TECHNICAL SERVICE BULLETIN

SUBJECT: DIFFICULT COLD WEATHER STARTING -
1961-62 CORVAIR "95" MODELS

BULLETIN NO. DR #528

REWIRE CORVAIRE "95" START CIRCUIT

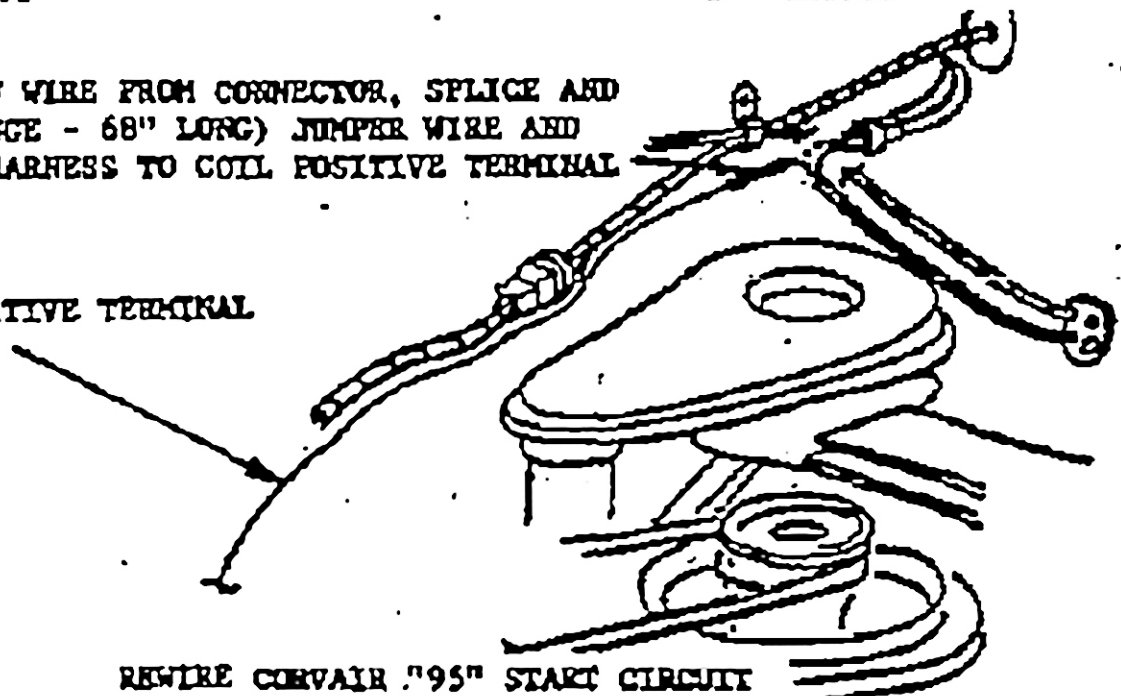
Difficult starting during cold weather on 1961-62 Corvaire "95" models, even though the engine cranks readily, may be due to only partial voltage being delivered to the engine ignition system. The normal ignition circuit includes a resistance wire, while the starting circuit should by-pass this resistance and furnish full voltage for starting. On Corvaire "95" models, this resistance was not being by-passed for starting and consequently, only the normal 6 to 7 volts was being supplied.

In the event this condition is experienced on 1961 and early 1962 vehicles, attach one end of a jumper wire (16 gauge - 68" long) to the yellow lead from the starter solenoid and the other end to the coil positive terminal as shown in the following sketch. This provides a by-pass of the resistance wire while on the starting circuit. Both wires (resistance and jumper) should be attached to the coil positive terminal.

This condition was corrected 3/9/62 in Production by adding a jumper wire as outlined in this bulletin. The approximate effective serial numbers are:

DISCONNECT YELLOW WIRE FROM CONNECTOR, SPLICE AND
SOLDER TO (16 GAUGE - 68" LONG) JUMPER WIRE AND
ROUTE WITH MAIN HARNESS TO COIL POSITIVE TERMINAL

TO COIL POSITIVE TERMINAL
